Memorandum

Subject: DRC-08-20 – Mike's Recycling

Design Review Committee DRAFT NOTICE OF DECISION

DRC 08-020, Mike's Recycling

Overall Site Plan

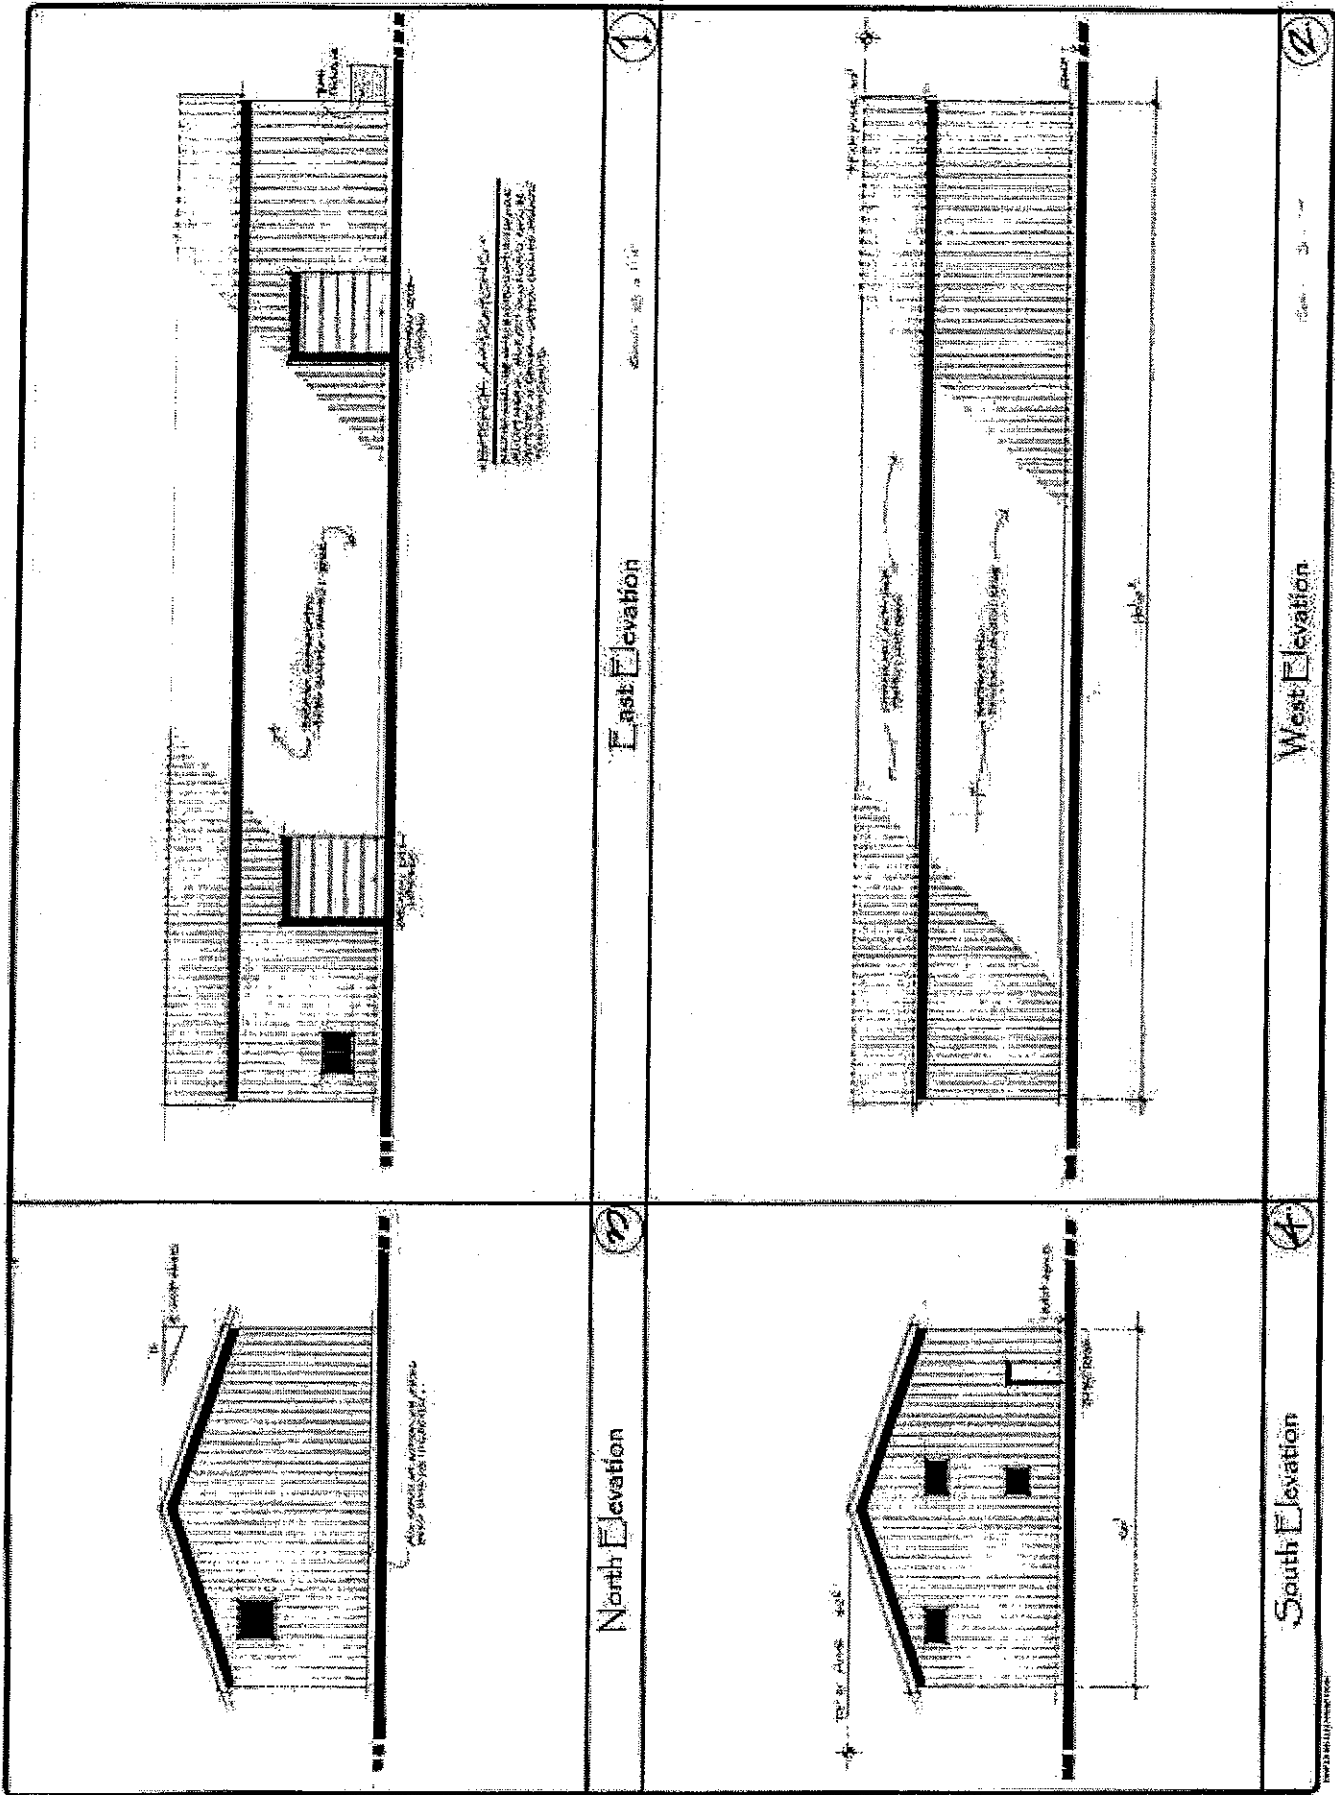
Hogan asked if the applicant anticipates a backup of traffic into the easement. Mr. Goodseal mentioned that thirteen parking spaces are required but they have add forty-four. There is a big open space for turn arounds, and ample space for back up.

18:50:56 Member Alberdi said he could not, as a Design Review member approve the building the way it's shown currently. Mr. Alberdi suggested that fencing needs to be added or maybe adding CMU facing the school and facing the back of the property so that it give the overall site a new image. Member Alberdi also stressed that the project is in the middle of certain uses as a citizen are very controversial, single family, park, elementary school.

The project site is a large site that has access from an existing 32-foot private easement across the MTS facility. The project site is a gated entry that provides a 23-foot plus entrance when open for business. The project site's gate entrance is located a sufficient distance away from Main Street and the project site contains sufficient area to avoid potential stacking, parking or circulation conflict with the existing MTS traffic and pedestrian flow (see Attachment 2, Site /Circulation Plan).

As indicated in the circulation plan, the customer would back up their vehicle to the loading docks/area for removal of their goods inside the building or park in one of the available on-site parking spaces and carry their materials inside the building. Bimonthly pickup by a vendor for the compressed cardboard stored along side the west side of the large building and weekly pickup by one vendor for recycled materials are anticipated.

STORAGE SHED ELEVATION

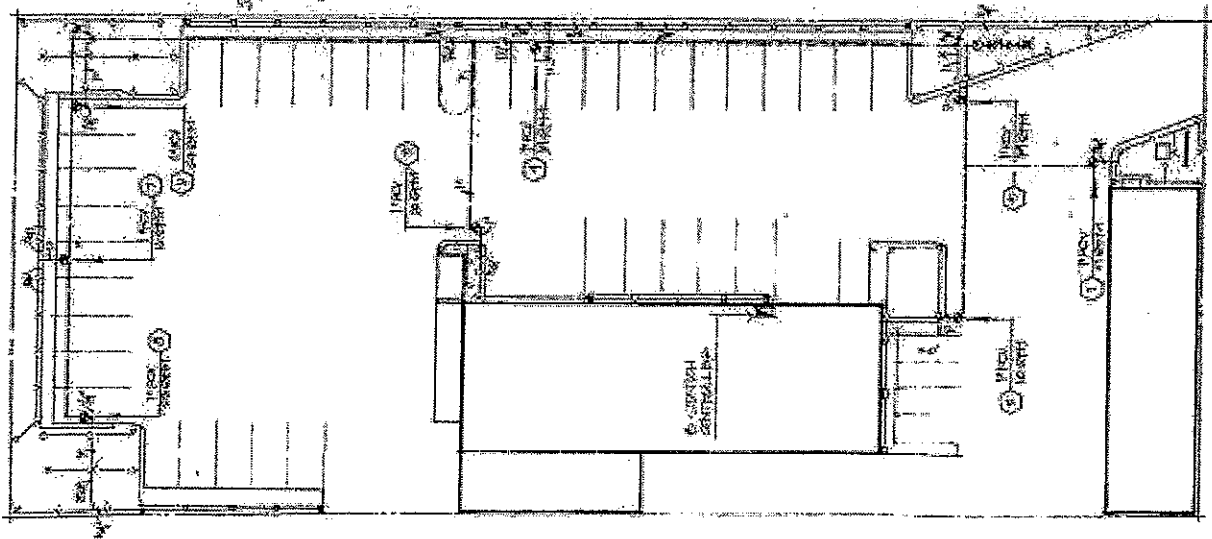
To provide the prominent architectural features and a holistic design treatment as requested by the Design Review Committee, the Applicant has since completed a project redesign that includes new architectural treatments and design features to the existing building elevations and stucco treatments to the existing western wall (refer to Page A-4/Elevations – Attachment 1). Proposed improvements include the following: remodeling the large industrial building with architectural pop out features that include stucco finish around entries and rollup doors, aluminum channels, 40" high CMU waiscott wall border around the buildings base, metal curved awnings, trim and façade border treatments to enhance the doors and windows, decorative lighting features, aluminum windows, and metal paneling/siding repair and repainting. A new 6-0 foot high CMU wall at both ends of the west perimeter matching the existing wall and color treated to blend with the waiscott wall treatments around the building base. Proposed improvements to the secondary accessory structure are primarily repainting the upper and lower levels to match the proposed beige siding with dark brown accent colors of the main building. Additional improvements include repair and repainting of the roof,

repair and repainting of the perimeter corrugated fencing and new trash enclosure with 6-0 foot high wall.
